Remarks

This is in response to the non-final Office Action mailed June 17, 2004. An Examiner's Interview was conducted with Applicant's Attorney Randall K. McCarthy, Reg. No. 39,297, on September 14, 2004 to discuss various issues relating to the Office Action, as reflected in the Interview Summary of even date. The Applicant's Attorney expresses his appreciation for the professionalism and courtesy extended by the Examiner during this interview.

FIG.3

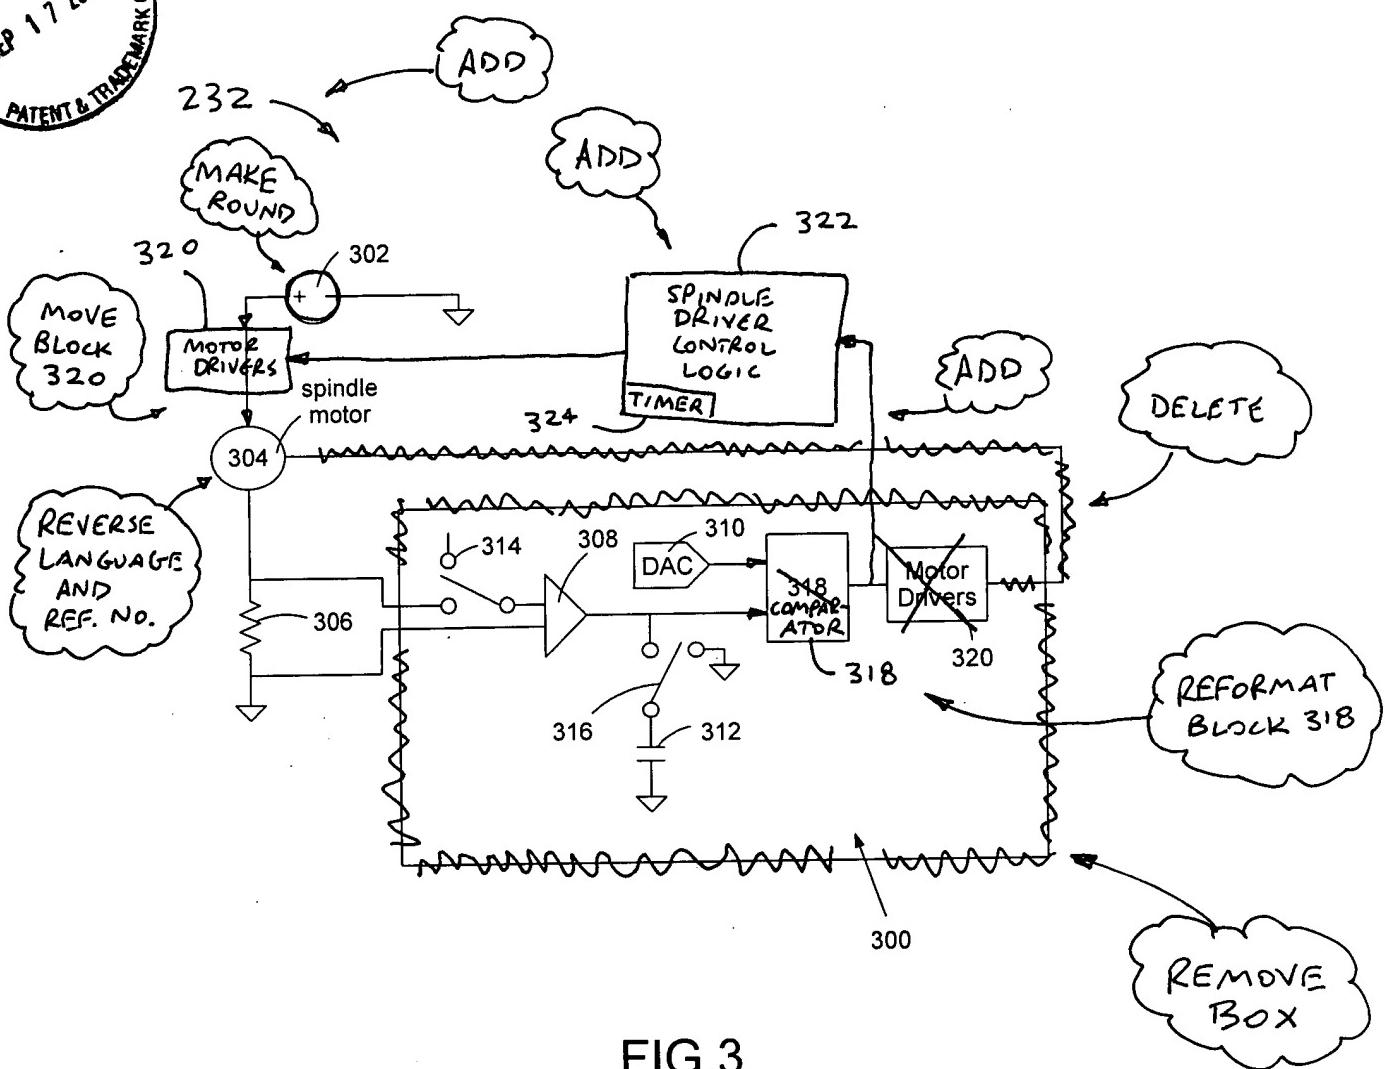
The Office Action objected to the drawings on the basis that the drawings must show every feature of the invention specified in the claims. FIG. 3 has been amended as discussed above, and it is submitted that these drawing amendments obviate this objection.

The drawings in FIG. 3 have been resized for readability and arrows added to better indicate flow. In addition, the following changes have been made to FIG. 3:

1. Numeral 232 and leadline have been added.
2. The circle at 302 has been rounded.
3. Block 320 has been moved.
4. Reference numeral 304 and language have been reversed.
5. Added block 322 Spindle Driver Control Logic with sub-block 324 Timer.
6. Lines to and from block 322 have been added
7. Block 318 Comparator has been reformatted.
8. Block 320 has been deleted.
9. Extraneous lines have been removed.

Accordingly, a new replacement FIG. 3 has been submitted above. This new FIG. 3 adds a "SPINDLE DRIVER CONTROL LOGIC" block 322 with associated "TIMER" block 324. Other minor amendments are provided as well to FIG. 3 to improve the clarity and readability thereof. Support for these amendments is found in the specification including at page 7, line 27 to page 8, line 4; page 9, lines 1-3; page 6, line 11; and page 9, lines 7-8. Corresponding amendments to the specification have also been entered at pages 6-9.
